Window Replacements for

Morehead City Middle School

Carteret County Schools
NCDSP Unit 160 - School 318

Project No. 22310
Date: 12 April 2023
Drawing no. BCS 001

EXTERIOR ELEVATIONS & DETAILS

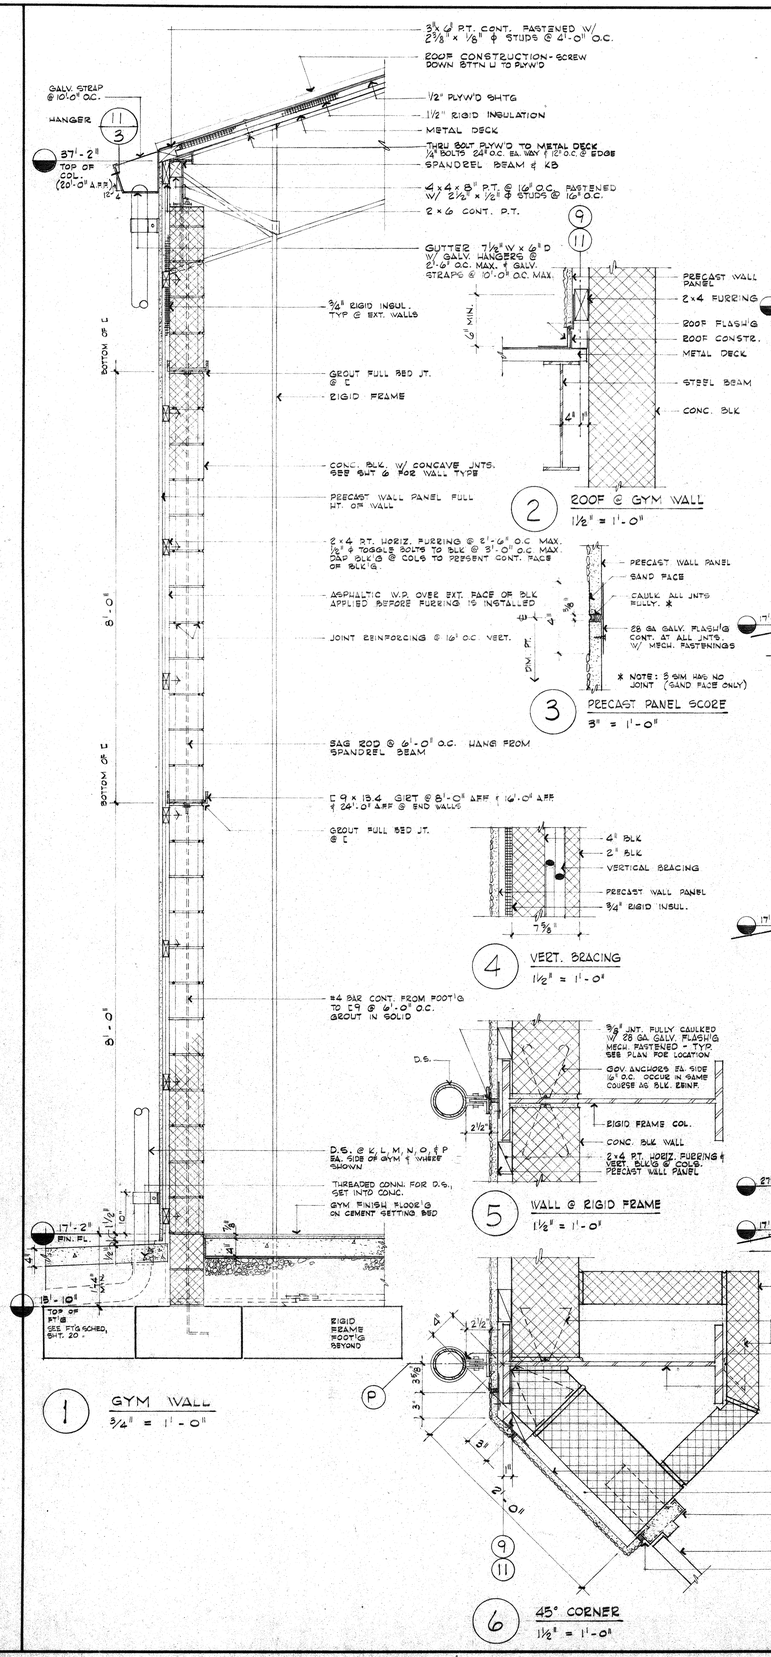
NOTE: UNLESS OTHERWISE NOTED, MATCH MULLION PATTERN WITH ALL NEW WORK

NEW GLASS AND FRAMING - TYP

PROVIDE EXTRUSION 1/4" PROUD OF FRAMING - TYP

.040" SILL FLASHING - TYP

PROVIDE NARROW EXTRUSION TO MAINTAIN DOOR WIDTH

NEW SPECIALITE DOOR - SEE A-101 DETAIL

THESE PAIRS SLIDING DOORS (3) CHANGED TO SWING DOOR WITH SIDELIGHTS AND TRANSOM SEE PLANS AND A-101

ADD MULLION AT BROKEN ANGLE GLASS - TYPICAL

LASS POD
MEDIA CENTER
PLAN 1/8"
DOOR SCHEDULE

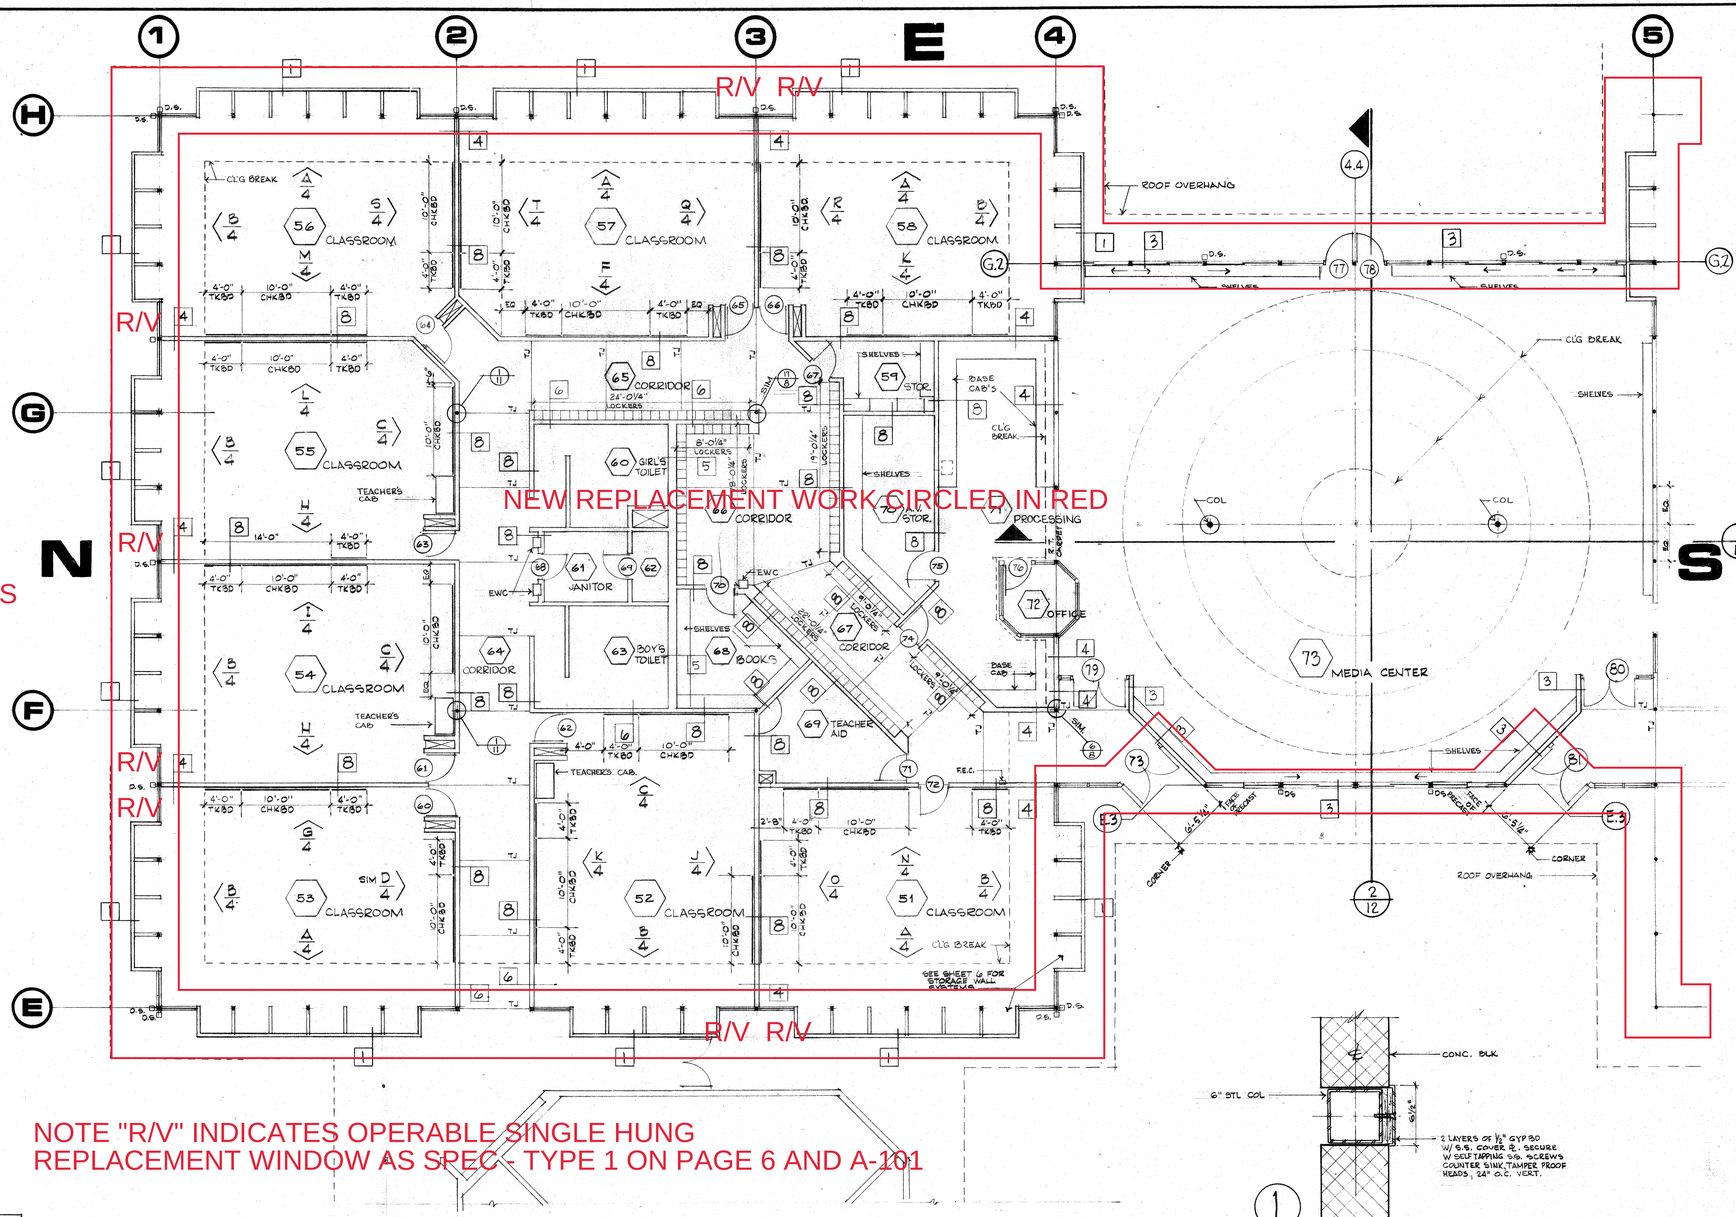
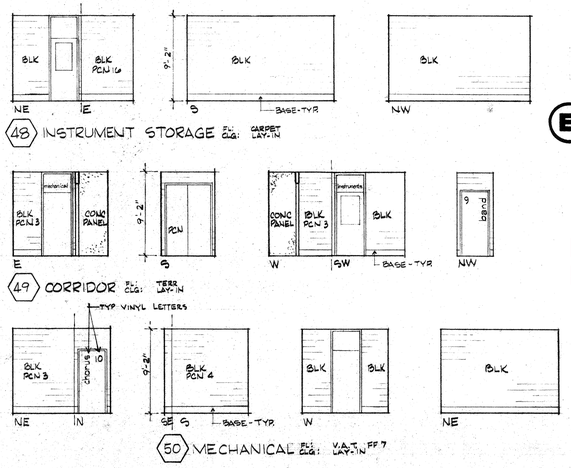
REFERENCE DOOR SCHEDULES FOR REPLACEMENT SIZES

NOTE "R/V" INDICATES OPERABLE SINGLE HUNG REPLACEMENT WINDOW AS SPEC - TYPE 1 ON PAGE 6 AND A-101

SIXTH GRADE POD
INDUSTRIAL ARTS
PLAN
DOOR SCHEDULE

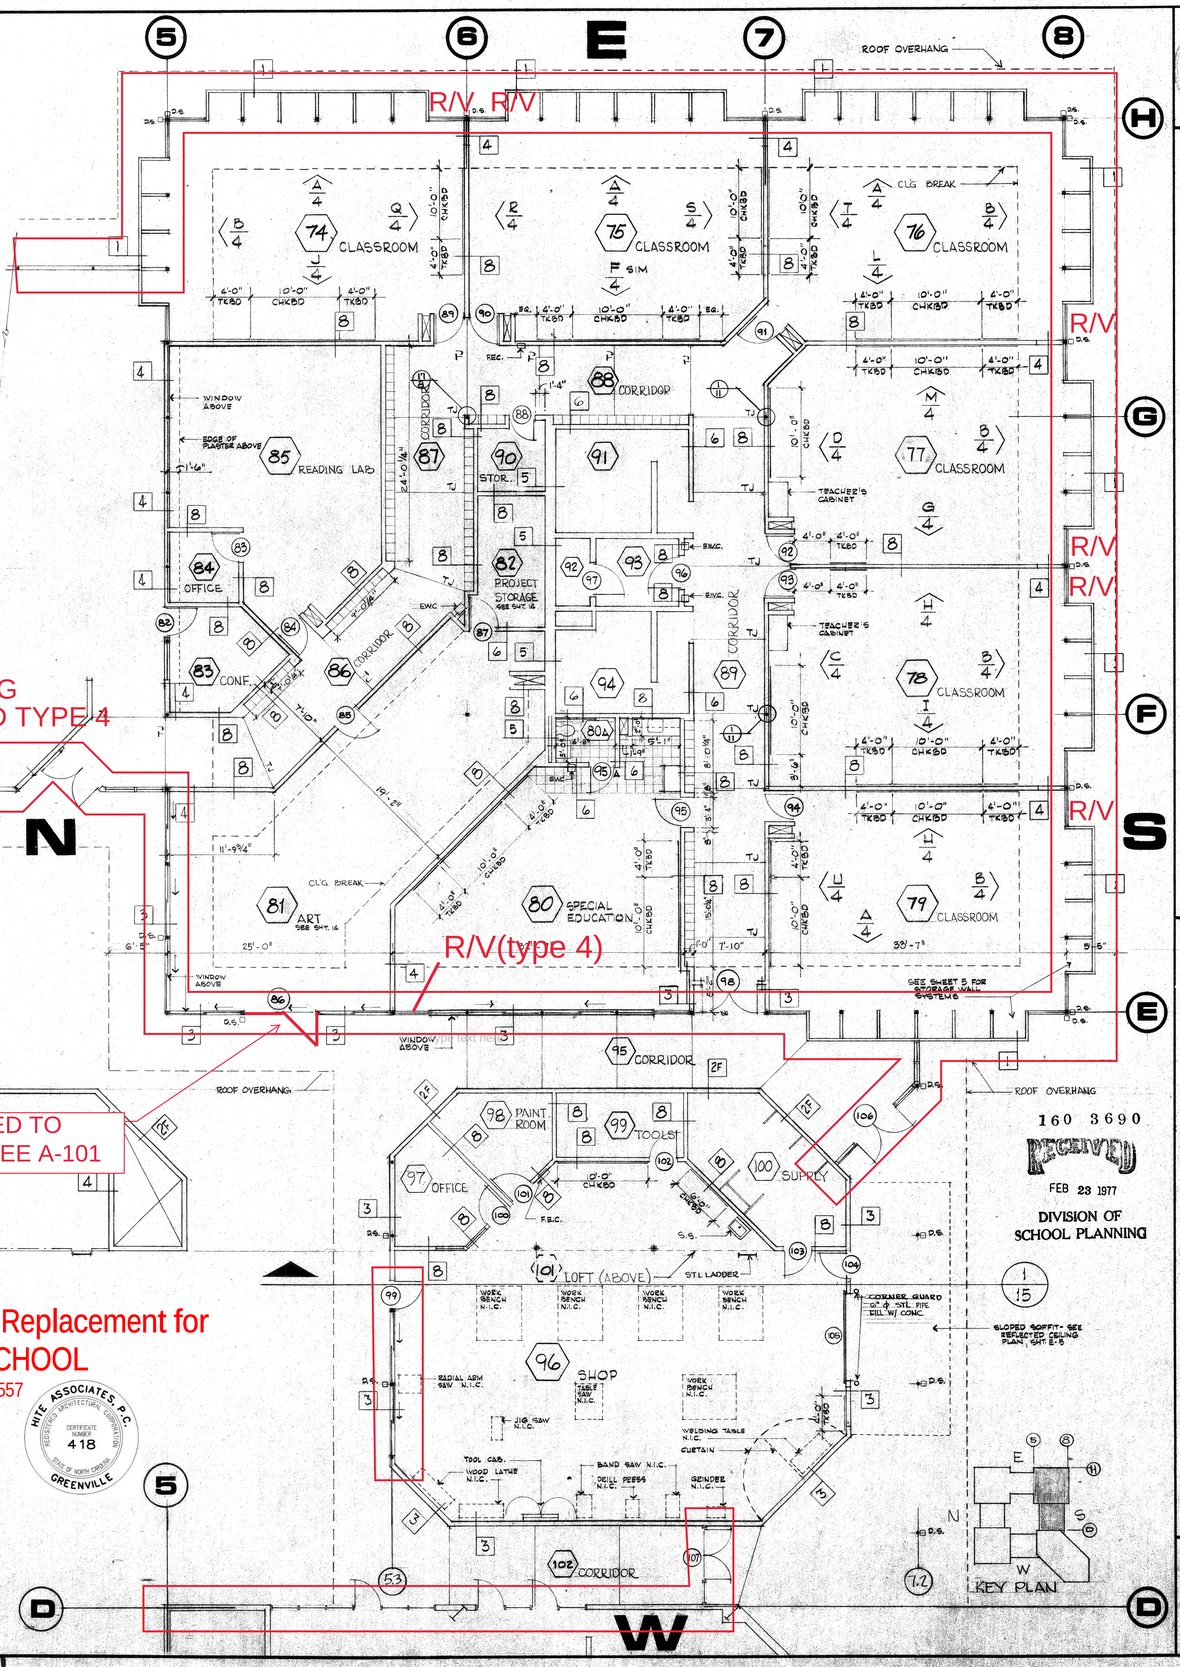
NOTE "R/V" INDICATES OPERABLE SINGLE HUNG REPLACEMENT WINDOW AS SPEC - TYPE 1 AND TYPE 4 ON PAGE 6 AND A-101

LOCKER ROOMS
PLANS 1/4" INTERIOR ELEVATIONS 1/4"
DETAILS

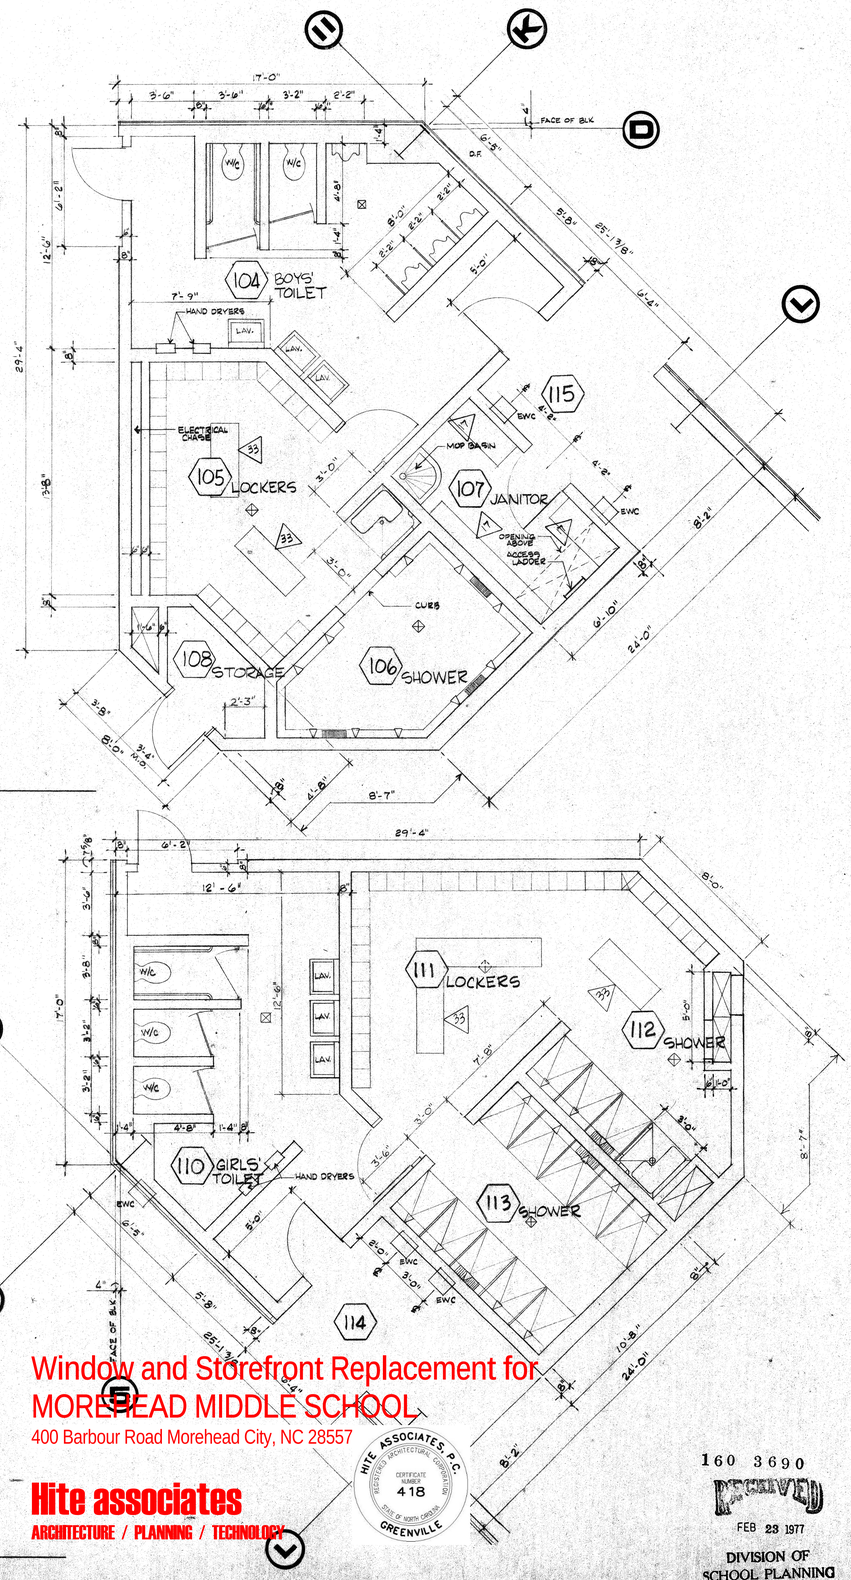
NOTE "R/V" INDICATES
REPLACEMENT WINDOW AS SPEC - TYPE 1 D A-101
